Reference: Hanford Waste Vitrification Plant
DOE Contract DE-AC06-86RL10838
Fluor Contract 8457

Transmittal No.: WDOE-924

DESIGN CHANGE NOTICE

DCN TITLE *ADD PAD MOUNTED
GEAR TO PRIMARY 13.8 KV
FEEDER FOR OAB/TOB
BUILDINGS*

NEW PAD MOUNTED GEAR
INSTALLATION DIAGRAM

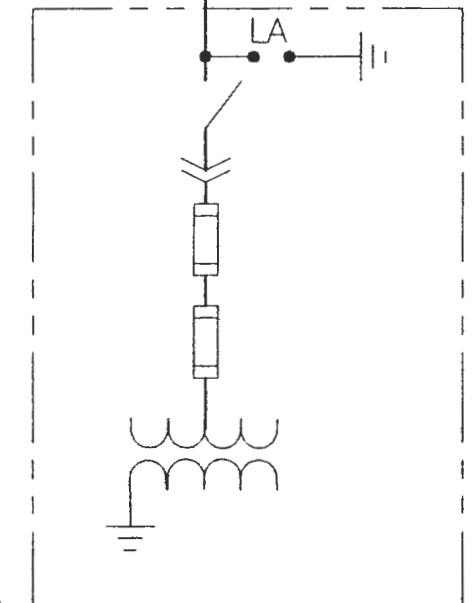
*ADD PAD MOUNTED GEAR NORTH OF MH-P51
FOR PRIMARY 13.8 KV FEEDER FOR OAB/TOB BUILDING*

NEW
DD-32A-100
PAD-MOUNTED GEAR

NEW CONDUIT
NOTE 3

NEW CONDUIT
NOTE 4

1. NEW PAD MOUNTED GEAR SHALL BE S & C MODEL PMH-7, 14.4 kV
2. PAD MOUNTED GEAR SHALL BE INSTALLED AND TESTED IN ACCORDANCE WITH MANUFACTURER'S INSTRUCTIONS AND SPEC SECTIONS B-595-C-A170-16100 AND 16905.
3. PULL BACK EXISTING CONDUCTORS P8300A,B,C @ MH-P51 FROM TRANSFORMER XT-32A-099. CUT CABLES (LENGTH AS REQUIRED) & INSTALL TO NEW PAD MOUNTED GEAR DD-32A-100 IN NEW CONDUIT P-8322 FOR TERMINATION HARDWARE SEE MATERIAL SPECIFICATION B-595-C-A170-16110.
4. INSTALL NEW CONDUCTORS P8304A,B,C FROM NEW PAD MOUNTED GEAR DD-32A-100 TO TRANSFORMER XT-32A-099 VIA MANHOLE MH-P51
5. CONDUIT & CABLE INSTALLATION SHALL BE PER SPECIFICATION B-595-C-A170-16100.
6. CONDUCTORS P8300A,B,C AND P8304A,B,C SHALL BE TESTED AFTER INSTALLATION IN ACCORDANCE WITH SPECIFICATION SECTION B-595-C-A170-16905.

MH-P51 ELEVATION

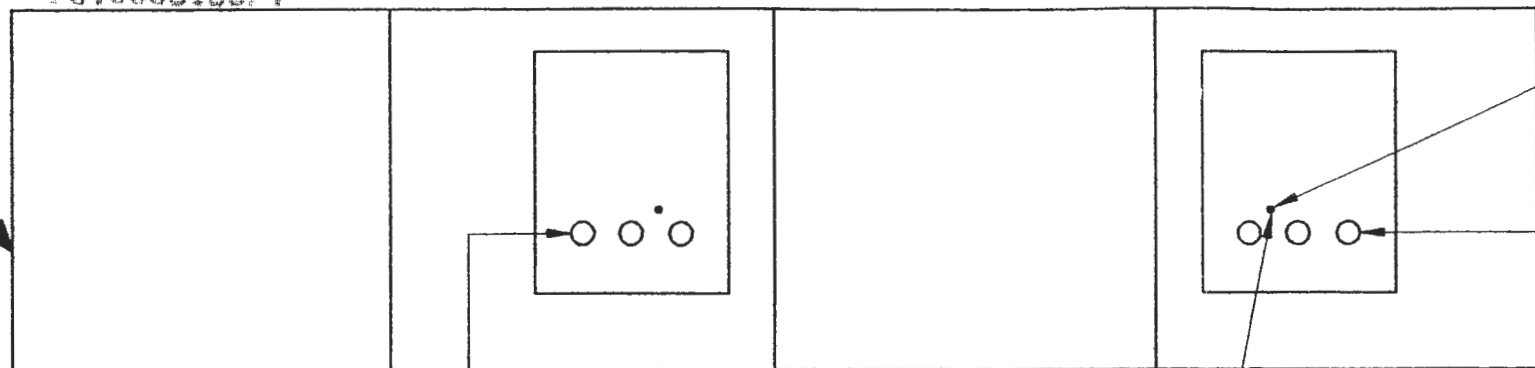
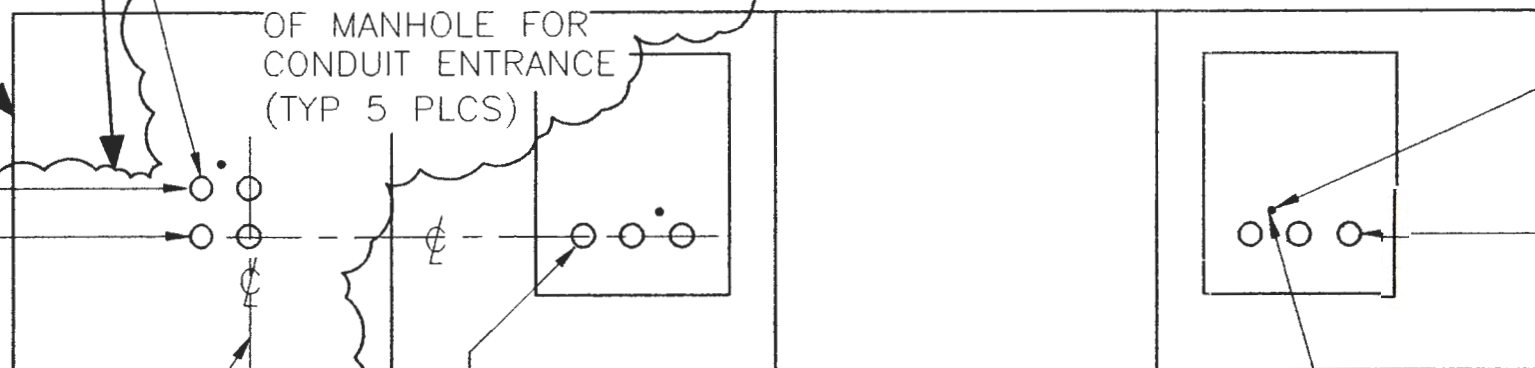
*PAGE 8; REVISED CONDUIT CALLOUTS
PAGE 10; ADDED CLOUD TO NOTE #5
PAGE 11; RESIZED ELECTRICAL DWCT
PAGE 12; REVISED CONDUIT STUB-UP SPACING
PAGE 13; REVISED CONCRETE PAD & ANCHORING OF
PAD MOUNTED GEAR*

CORE DRILL NORTH WALL
OF MANHOLE FOR
CONDUIT ENTRANCE
(TYP 5 PLCS)

THE INFORMATION CONTAINED ON
THIS PAGE TO BE INCLUDED ON
SHEET 4 OF DRAWING H-2-122134
WHICH WILL BE ADDED AT THE
NEXT REVISION.

SECTION "A-A"

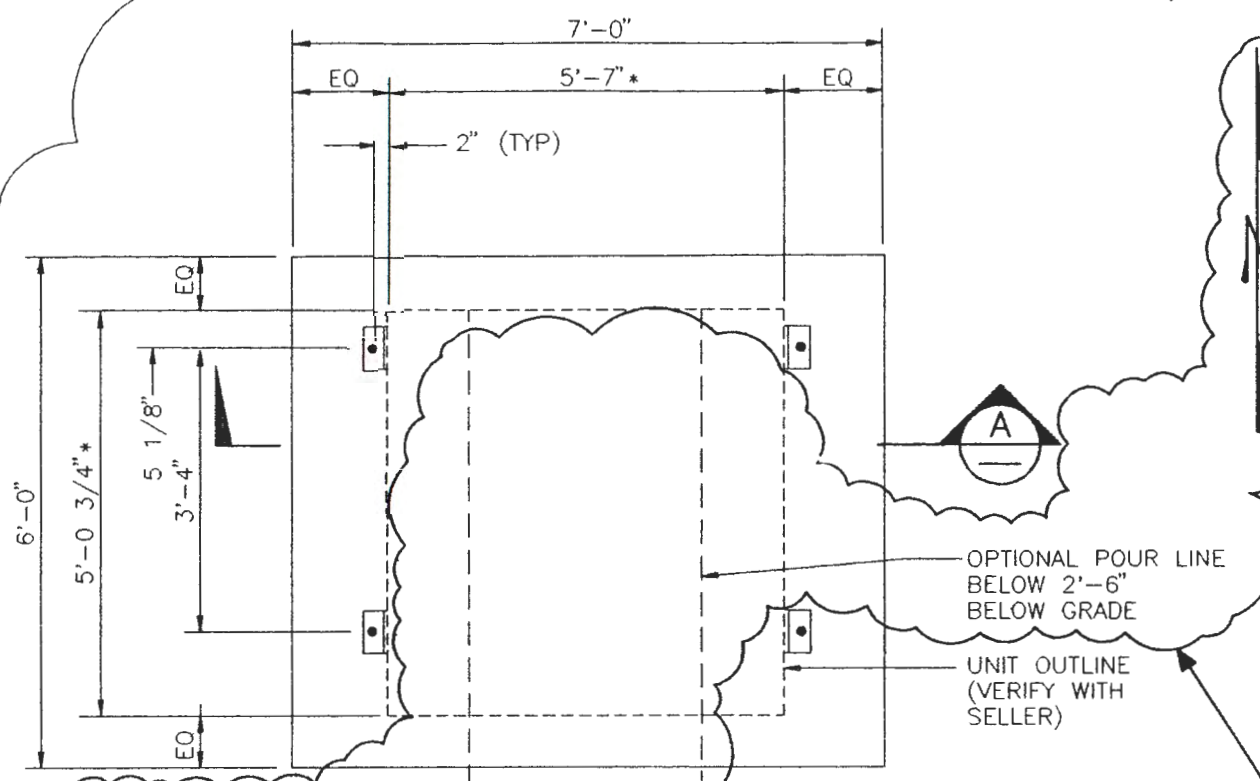
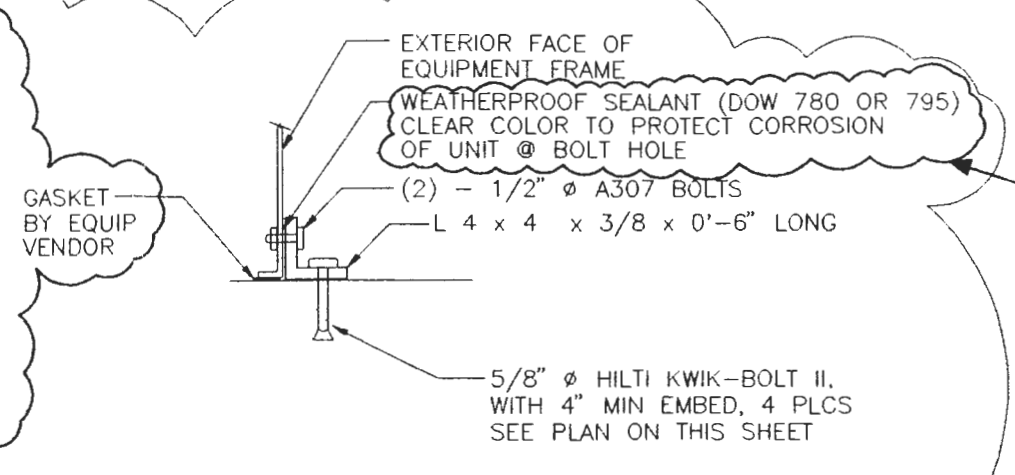
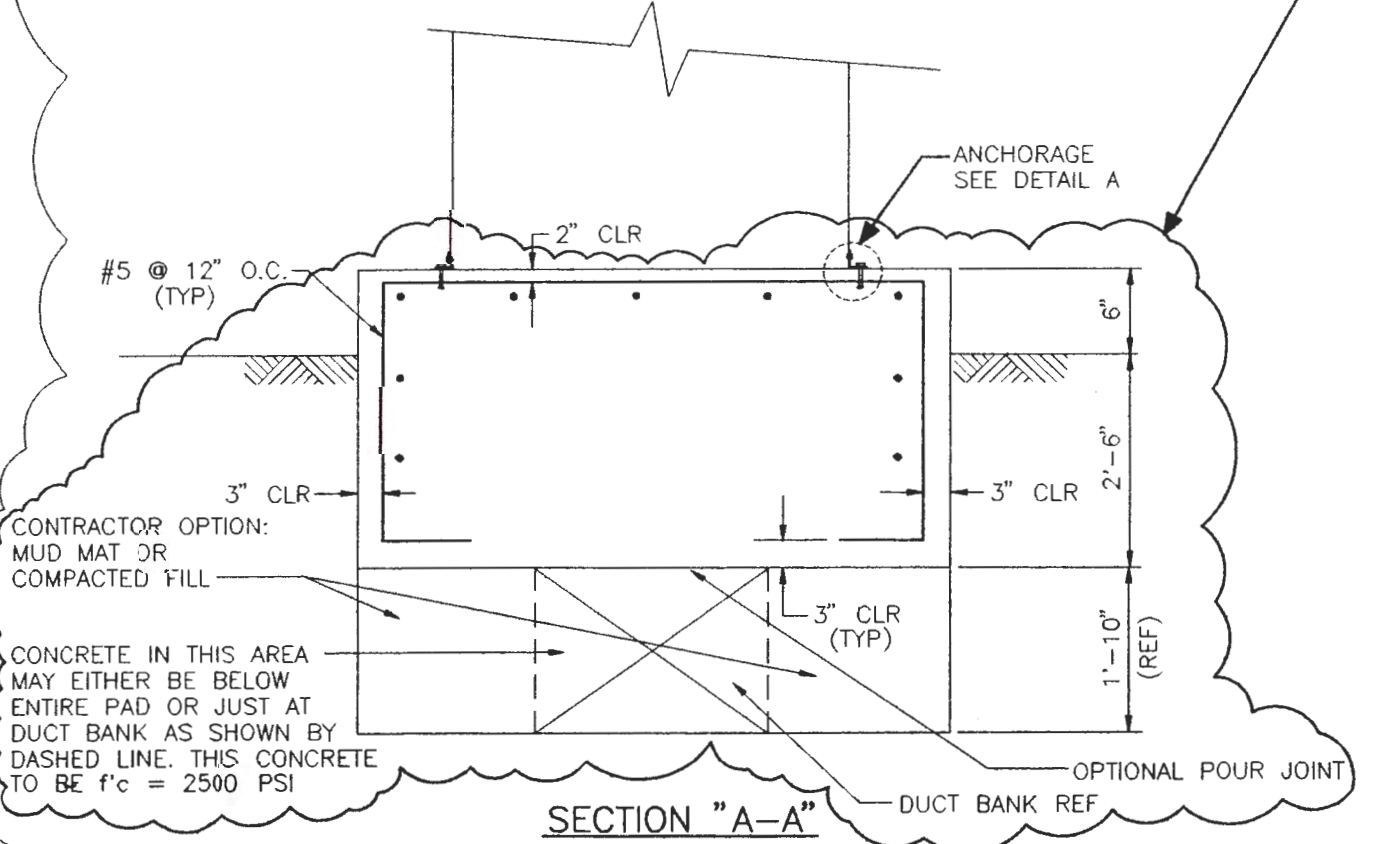
DOCUMENT NUMBER	SHT/PAGE	REV NO	DOCUMENT NAME	INCLD Y/N	DESCRIPTION OF CHANGE
H-2-118063 REV 1 CHANGE	1	2	DISCONNECT SWITCH PAD FOUNDATION	Y	ADDED PAD FOUNDATION FOR PAD MOUNTED GEAR NORTH OF MH-P51

1. KWIK-BOLT II SHALL NOT BE INSTALLED UNTIL CONCRETE HAS REACHED $f'c = 2500$ pSI.
2. REINFORCING MAY BE MOVED UP TO 3" FOR CONDUIT BUT AVERAGE SPACING TO STAY AS SHOWN. ALT.: IF A BAR HAS TO BE REMOVED FOR A CONDUIT, ADD EQUIVALENT REIN. ADJACENT TO UNREINFORCED ZONE.
3. SEE SHEET H-2-118060 SHEET 1 FOR STRUCTURAL GENERAL NOTES & TYPICAL DETAILS.
